Planning applications, references 18/0547/FUL, 18/0548/FUL and 18/0549/FUL:
Representations on additional information

Annex: Selected Errors in Technical Note TN040

H04:

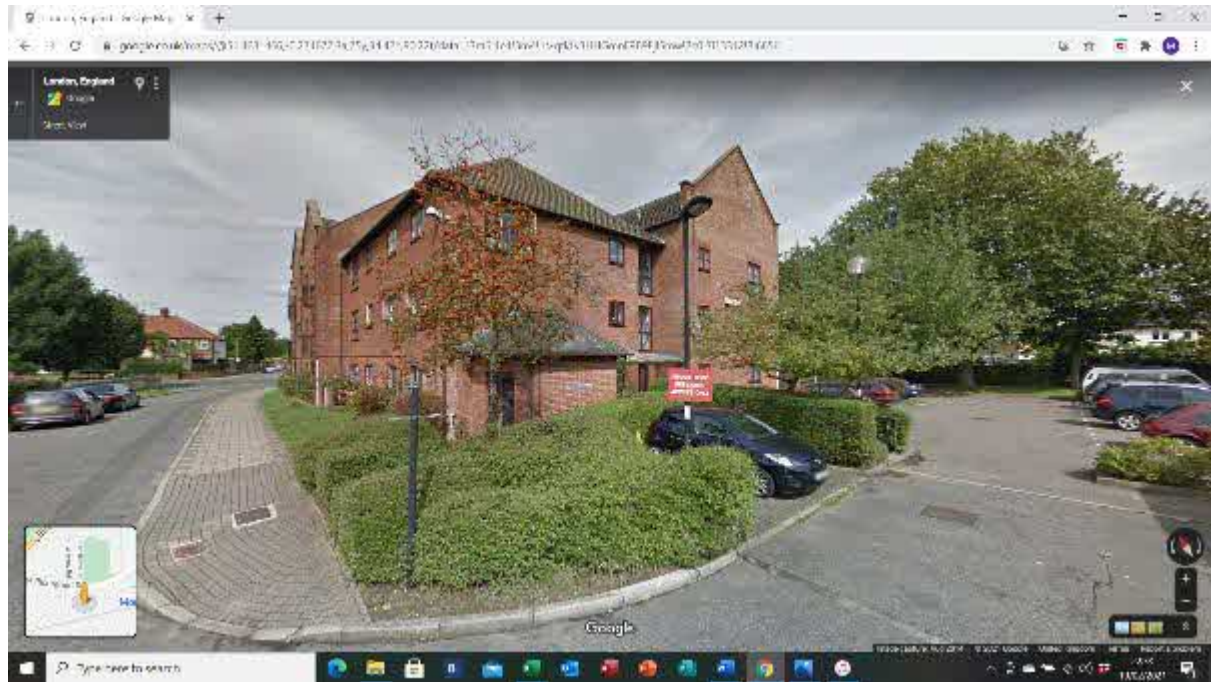
The two Green areas are divided by a small Red section, marking the site of a dropped kerb ramped access to a side door of the building until recently used as a community centre. This is shown in Photos H02, H03 and H04 – partly obscured by a grey car. Although the building appears currently unused (such that cars feel able to block the ramp with impunity), it should be assumed that it will recommence operations in due course, at which point this access point will again be required and parking in front of it impossible.

L01:

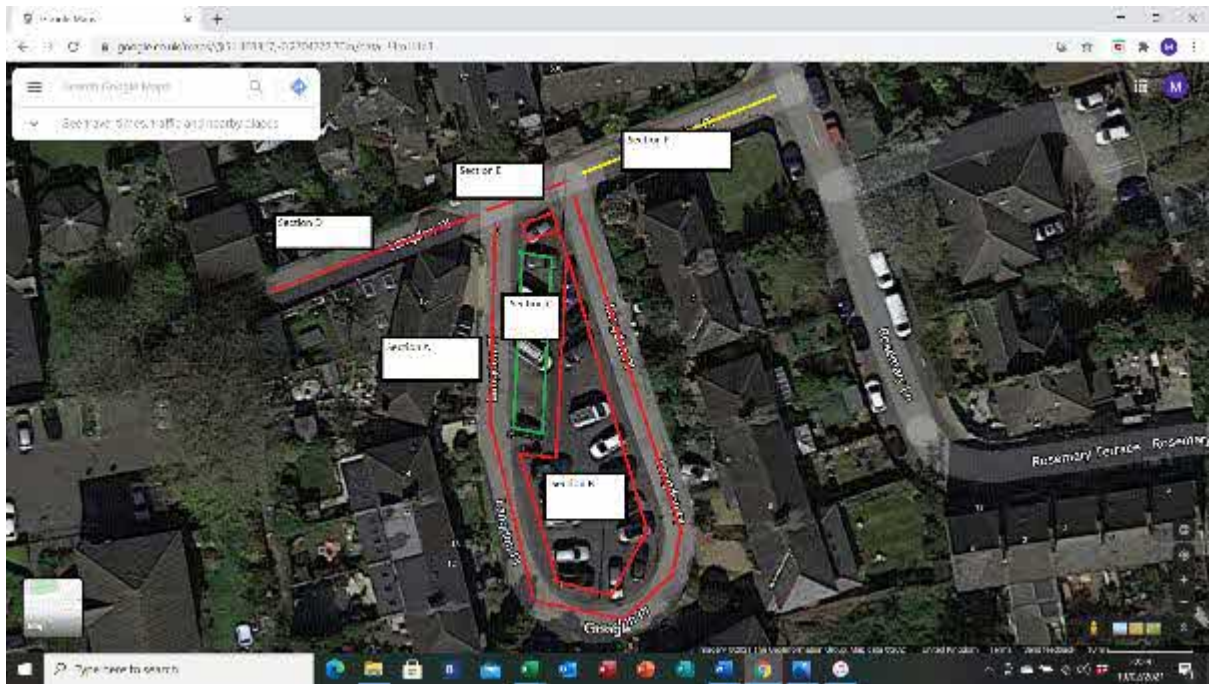
Although small, Langdon Place is complicated in terms of parking availability: several different sections of the road have to be considered individually. As highlighted on Photo L01, these are as follows:

Although individual bays are not marked out within this parking area cut into Section B, it is apparent (see Photos L01, L02 and L03) that a total of 8 cars can fit into it, if parked parallel with the side edges of the cut-out section – i.e. facing into Section B.

S05:

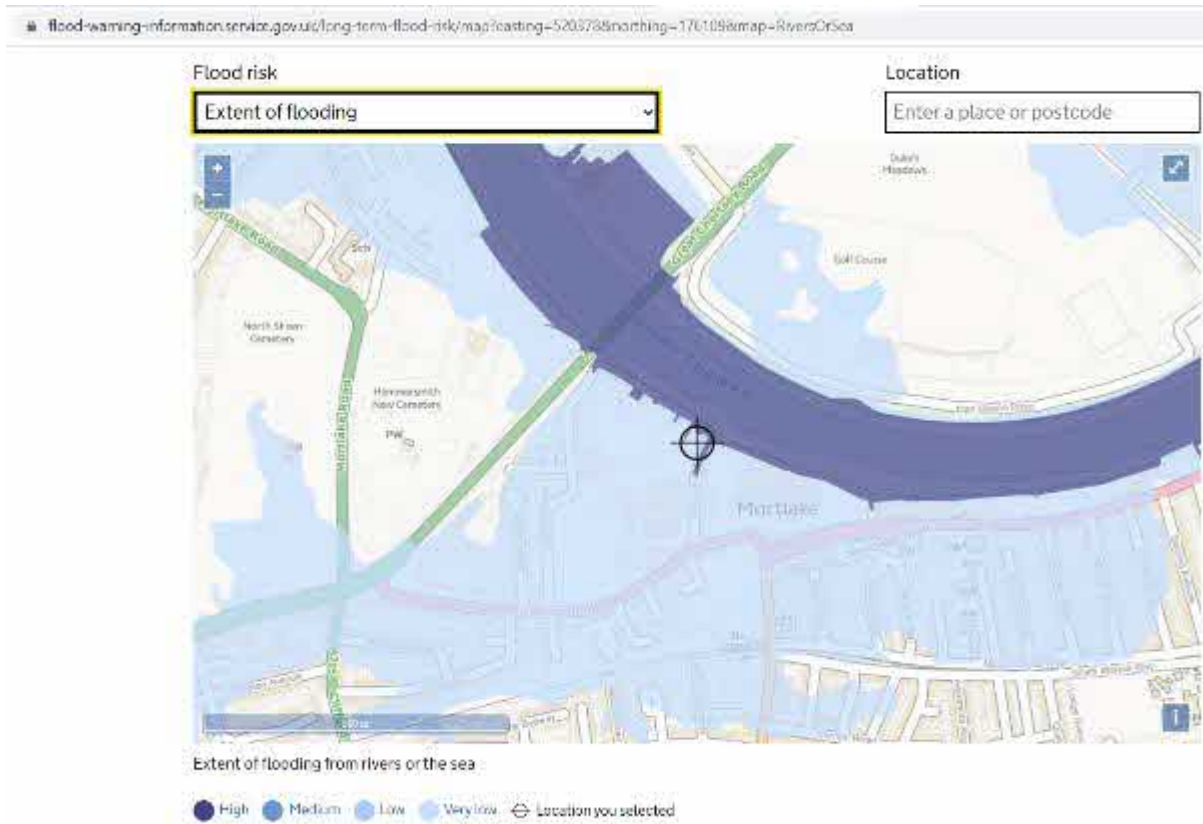
However, not all of Ship Lane is available for parking all the time: the northern section of it is subject to tidal flooding. As Photo S05 shows, the UK Government's Flood Warning Information Service assesses the northern section of Ship Lane (along with the whole of Thames Bank) at "High" risk of flooding. Using the scale in that photograph, it can be seen that the northernmost 60m of the road falls into the "High" risk category – equating to parking for 12 cars. Deducting this figure from the previous total of 24 cars leaves a future permanent availability of only 12 cars.

Secondly, and even more fundamentally, the whole of Thames Bank is liable to flooding. As Photo S05 shows, the UK Government's Flood Warning Information Service assesses Thames Bank (along with the northern section of Ship Lane) at "High" risk of flooding. The flooding of Thames Bank is not simply a "risk": it happens frequently. On the day on which the measurements in this paper were taken (19 February 2021), the tidemark from a recent tide high enough to cause flooding was visible as far inland as Parliament Mews (i.e. having washed fully across Thames Bank) – see Photo T03.

W19:

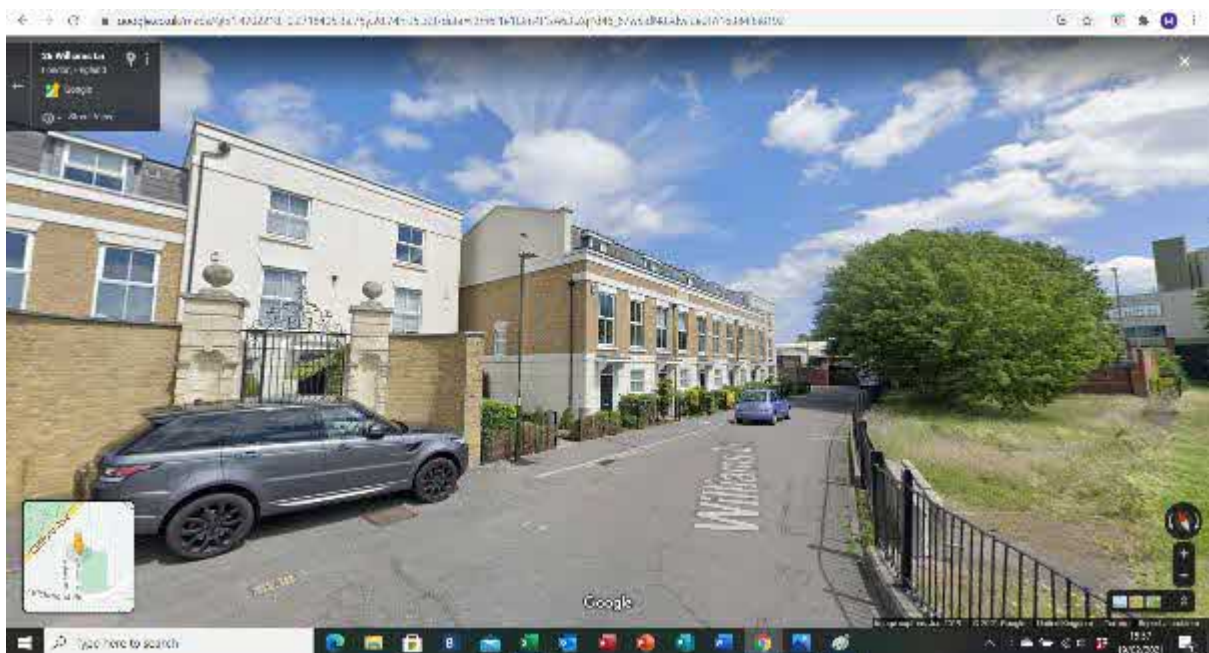
Photos W18 to W20 demonstrate this. In Photo W20, a Transit van will just have room to pass the blue car, but only because it is a small car and has pulled up tight against the kerb. The inability of larger vehicles to park legally in this stretch of road while allowing other vehicles to pass is shown by the fact that the grey SUV has instead opted to park (illegally) on the pavement.
